FIRST AMENDMENT TO THE DRAFT ENVIRONMENTAL IMPACT REPORT

CONSISTING OF COMMENTS, RESPONSES TO COMMENTS, AND TEXT REVISIONS

RICHMOND RANCH RESIDENTIAL DEVELOMPENT

(PDC 91-10-081)

LEGEND Project Boundary Misery Creek Watershed -aux Creek Watershed mpson Creek Watershed USGS Topographical Man (Control HATERSHED MAP FIGURE 24

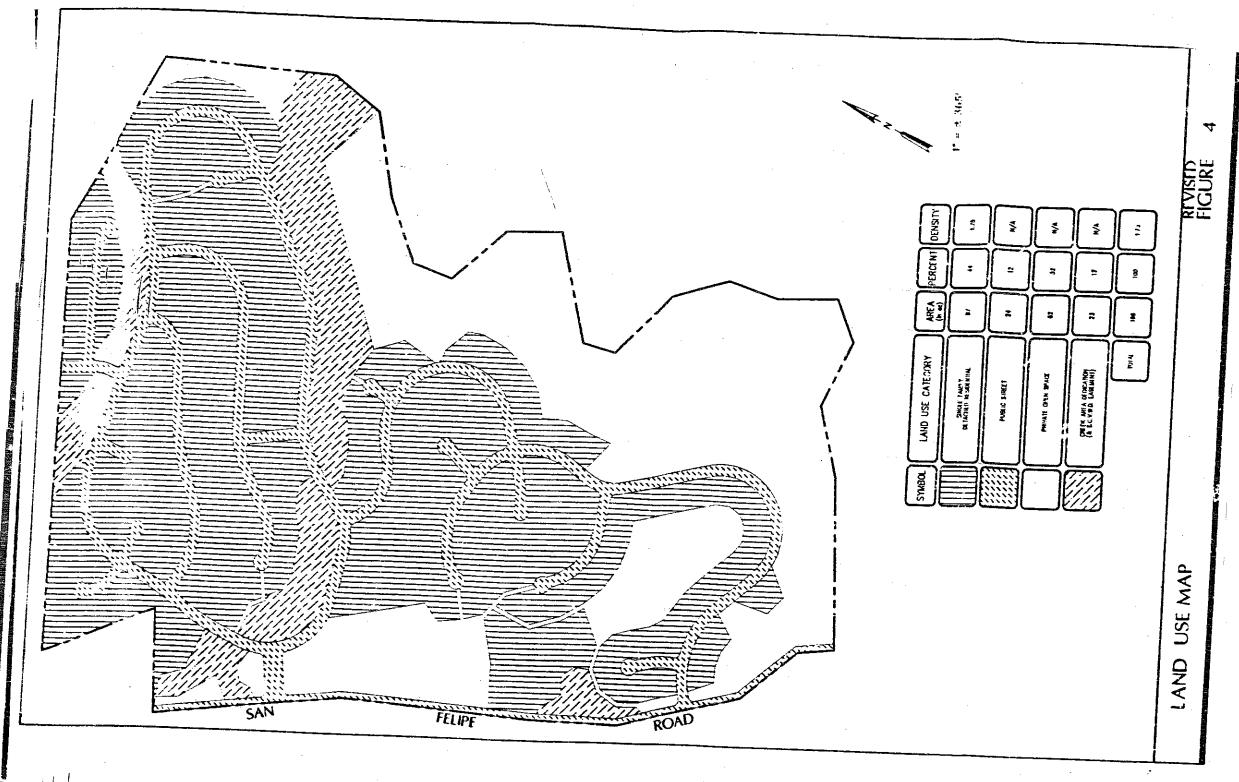
- A. RESPONSES TO COMMENTS ON THE DRAFT EIR FROM THE SANTA CLARA VALLEY WATER DISTRICT DATED OCTOBER 30, 1992
- A.1. <u>COMMENT:</u> The site is traversed by three District facilities, Thompson Creek adjacent to San Fetipe Road, Misery Creek to the north, and Hawk Creek through the center of the site. It appears from the plans that the subwatershed boundaries of these three facilities will be affected. We need to see the exact boundaries of the site on the watershed map enclosed with this letter.

The site is traversed by three District facilities, Thompson Creek adjacent to San Felipe Road, Misery Creek to the north, and Hawk Creek through the center of the site. It appears from the plans that the subwatershed boundaries of these three facilities will be affected. We need to see the exact boundaries of the site on the watershed map enclosed with this letter.

<u>RESPONSE</u>: A copy of the USGS topographical map showing the project site and the watershed areas for Misery, Hawk, and Thompson Creeks is provided as Attachment C in Section III of this Amendment to the Draft EIR.

Add Attachment C, Fig are 12a to the Drainage Section of the Draft EIR.
